HILLS OF GOLD WIND FARM SSD 9679

Topics for submission to DPIE concerning Hills of Gold Wind Farm EIS

Comments by Peter Hooper - Morrisons Gap Rd - January 2021

The Devils Elbow: Two Views, c1890 and 2018

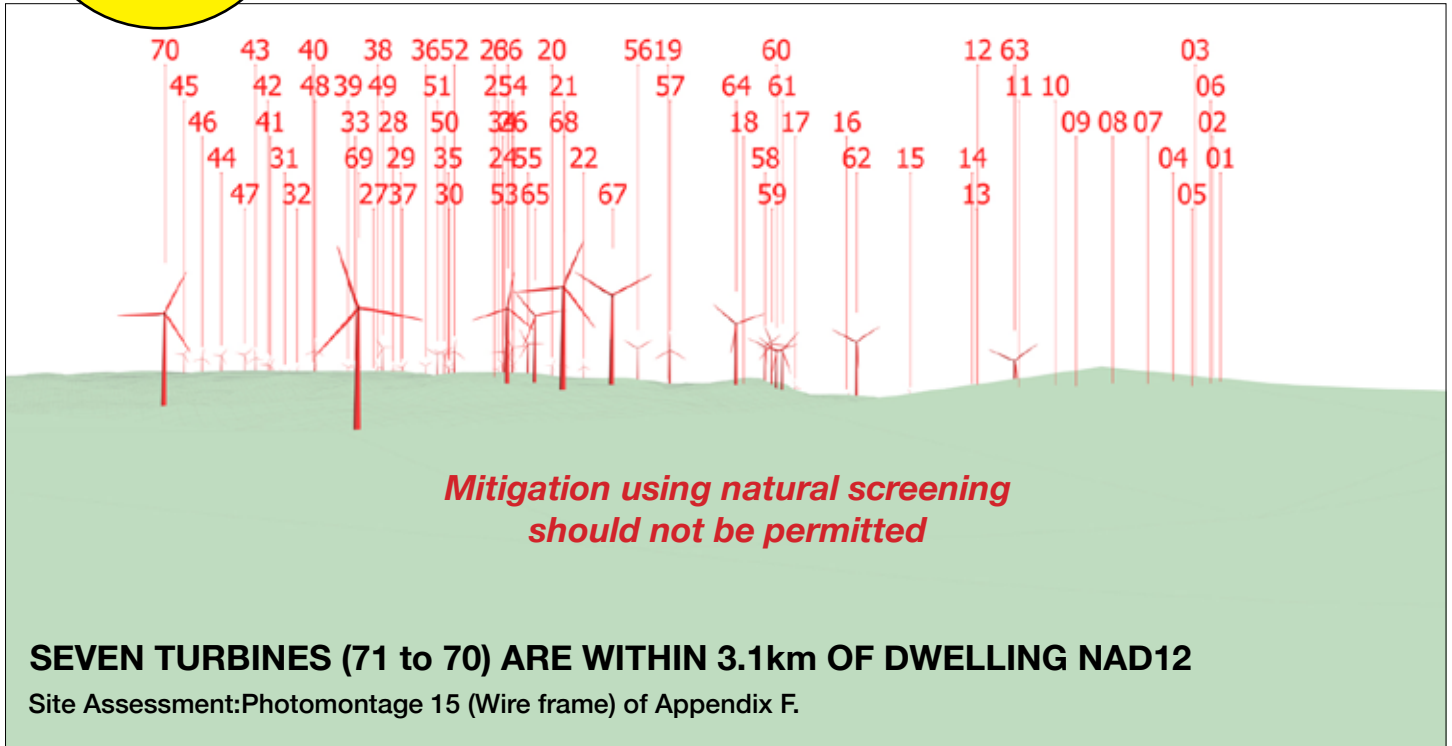
Do not change the vibe of Devils Elbow

Preservation of an area such as Devils Elbow and its surrounds is historically important in protecting as much as possible the landform as it existed in Hanging Rock's gold mining era.

Photomontage 15 (Wire frame) of Appendix F. with Turbines 65 to 70 removed

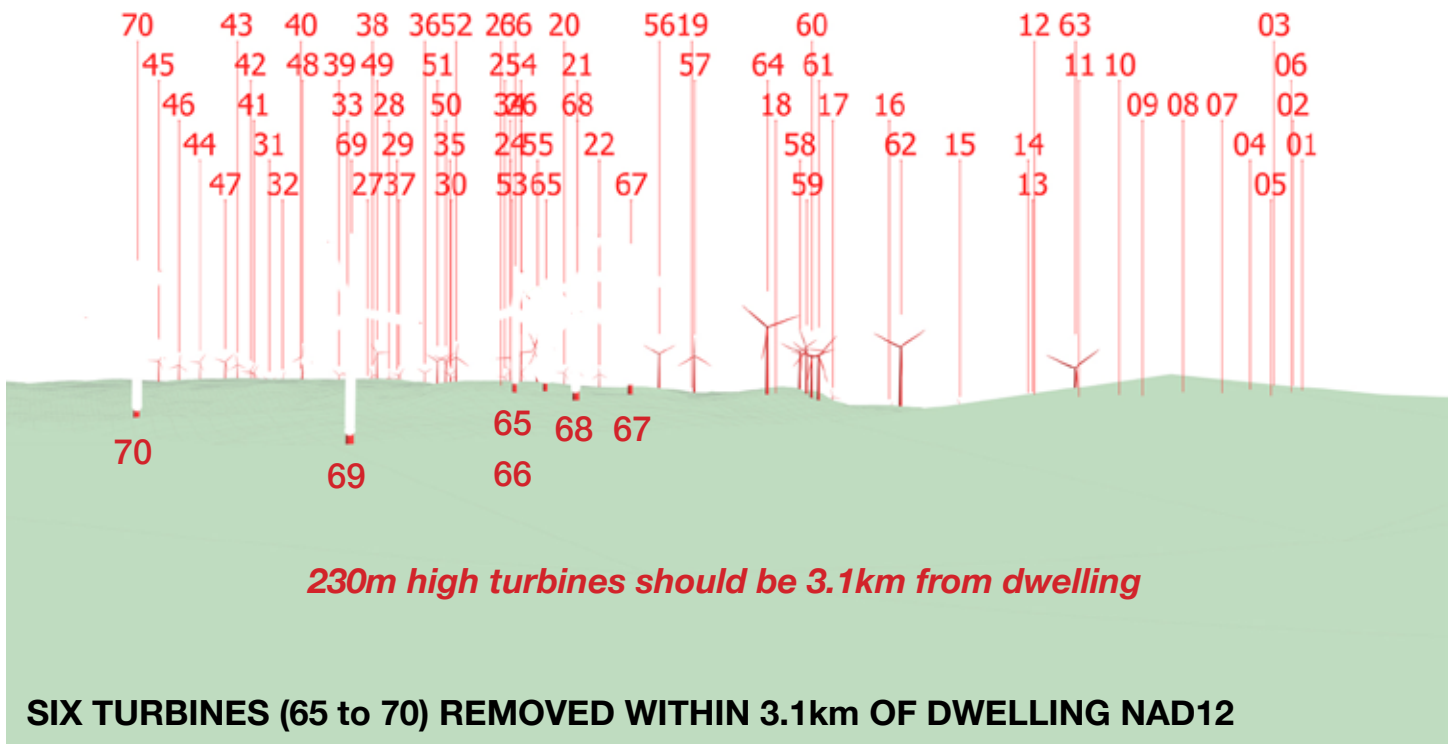
2 - Will the Proponent relocate SIX turbines WP65 to WP70 elsewhere on the project site so they are not as close as 1.2km to my dwelling but at least 3km away?

Approximately 60 to 70 turbines would be visible (based on topography alone), with **seven turbines within 3100 m**. Limited filtered views are available through the vegetation towards the Project Area. (App. F LVIA App. D PM15)

**NAD-12
SWEPT PATH
IMPACT
FOR BLADE
OVERHANG**

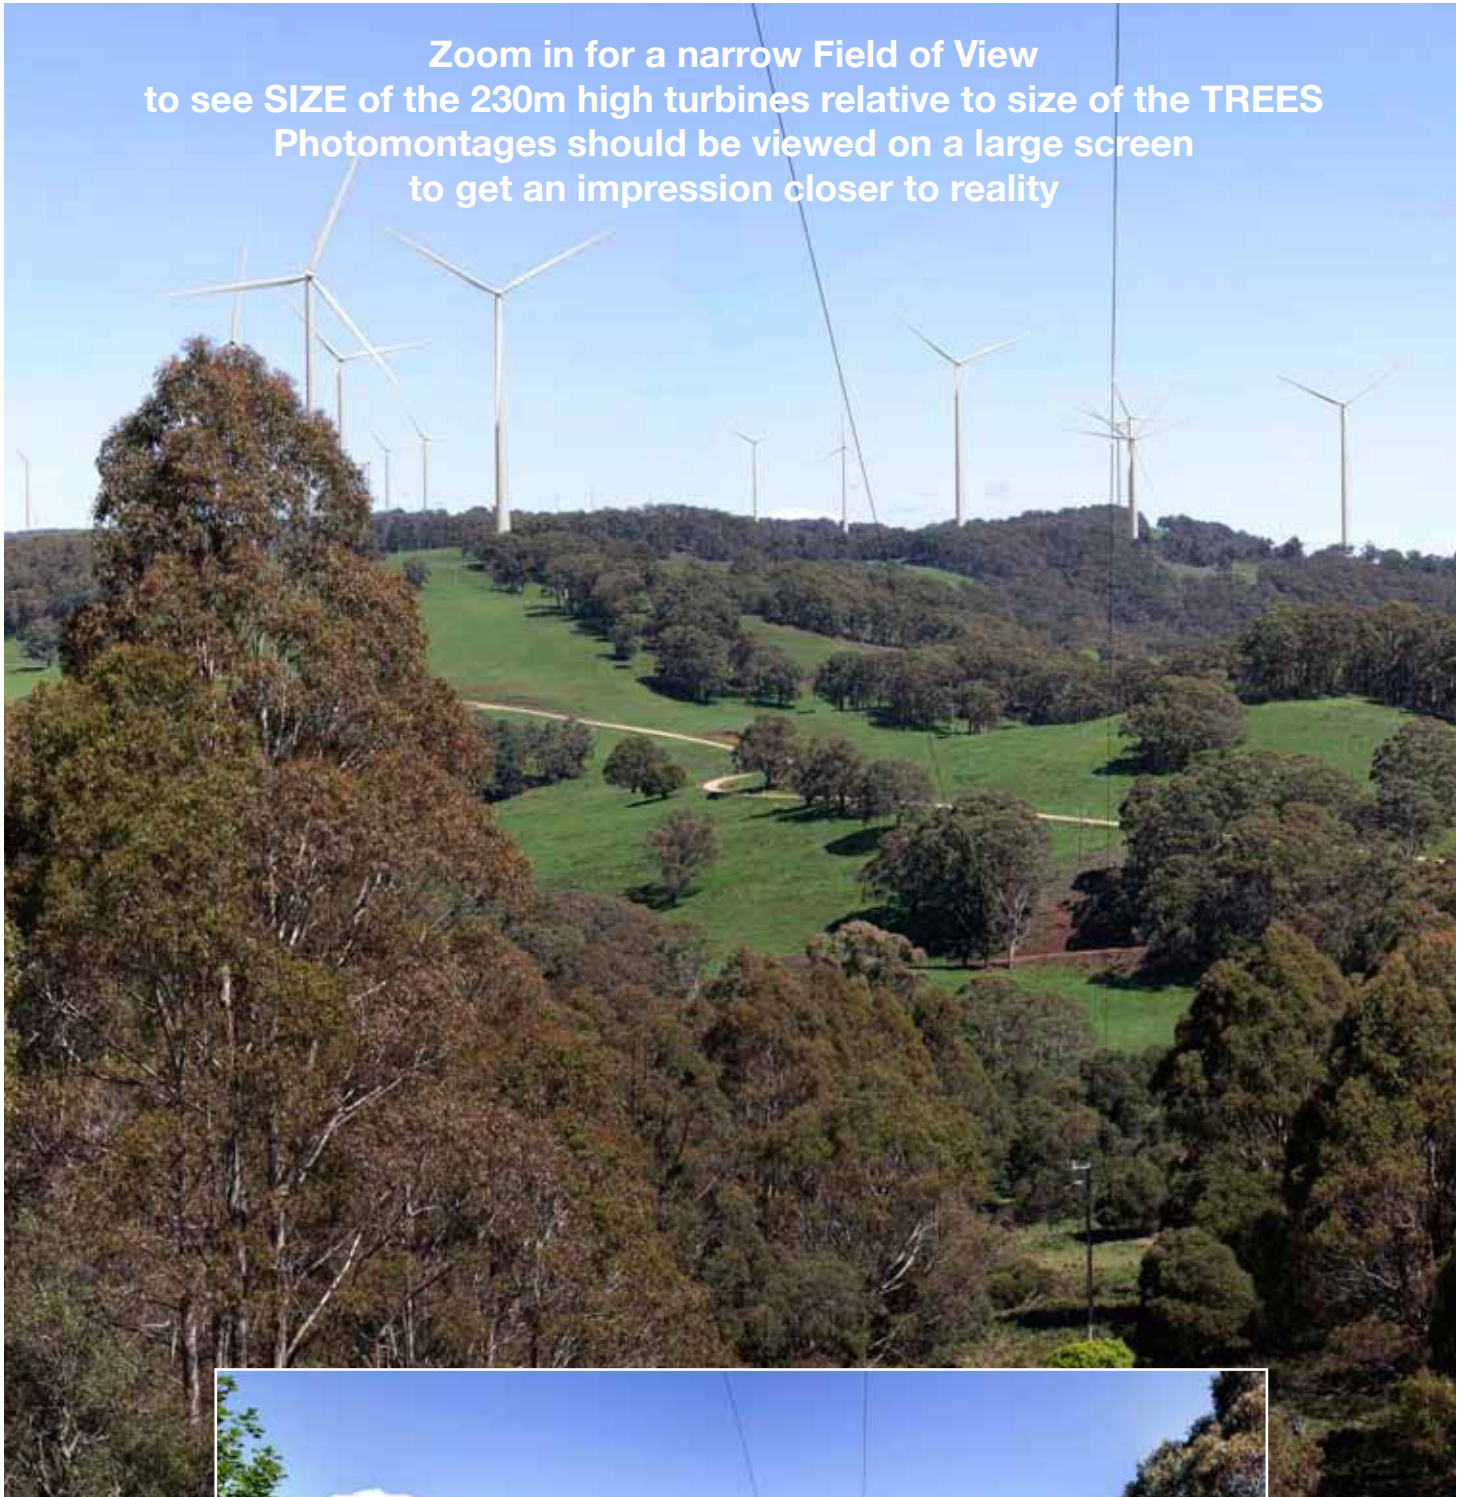
REMOVAL OF VEGETATION FOR BLADE OVERHANG

• Our precious birch tree driveway - planted 1985

SOLUTION
GO HEAD OF PEEL RD
TO AVOID IMPACTS ON
MORRISONS GAP RD

Photomontage 09

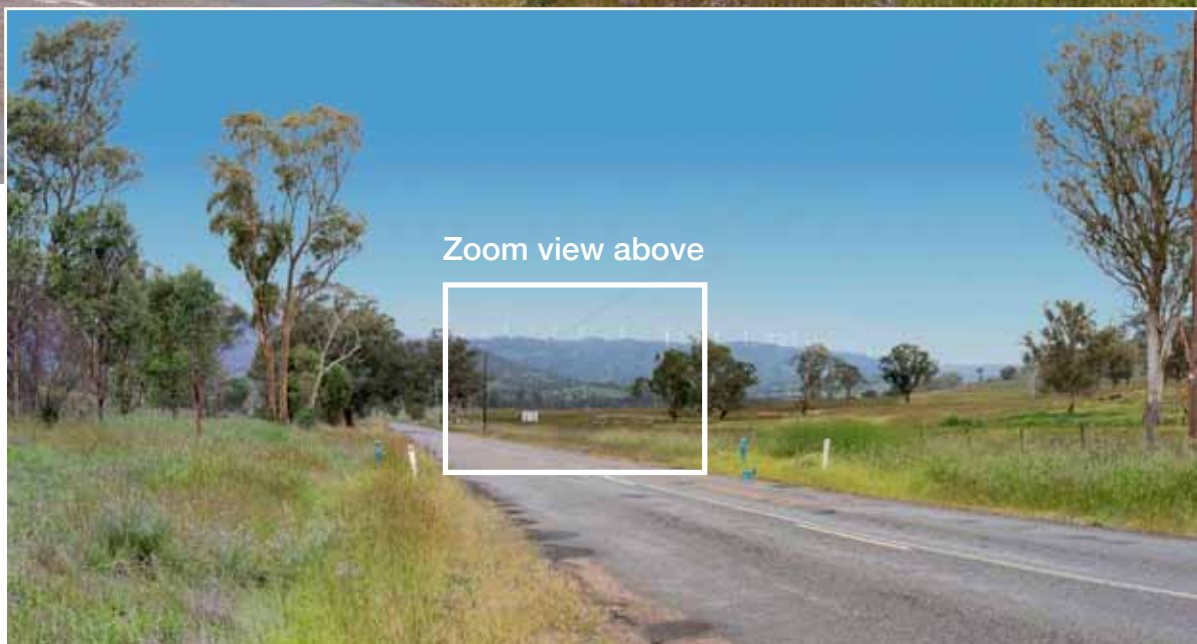
- The photomontages (PM01 and PM09) showing the approach to Nundle fail to indicate the large scale of the turbines relative to the height of ridgeline. Photomontages must be viewed on a large screen.
Ref: pages 20 & 21

Zoom in to see SIZE of the 230m high turbines relative to size of the HILLS

App F LVIA App D PM 01: Proposed View - 60 degree Field of View

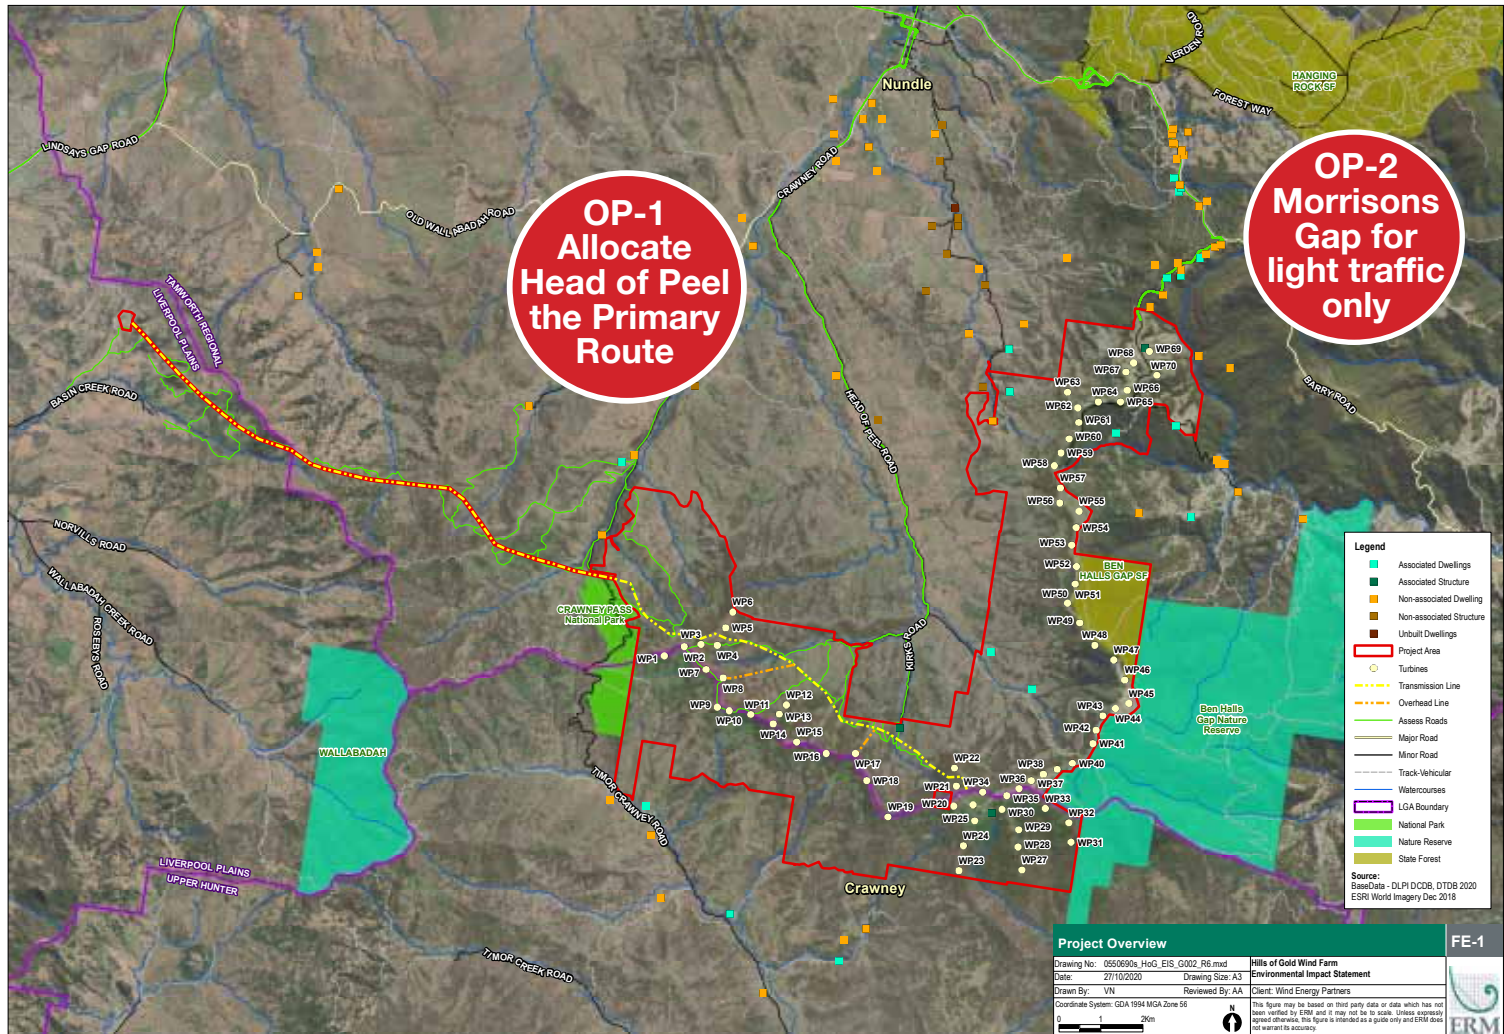
Is the Cumulative Visual Impact *acceptable*?
BIG CHANGE IN CHARACTER FOR THE HILLS OF GOLD
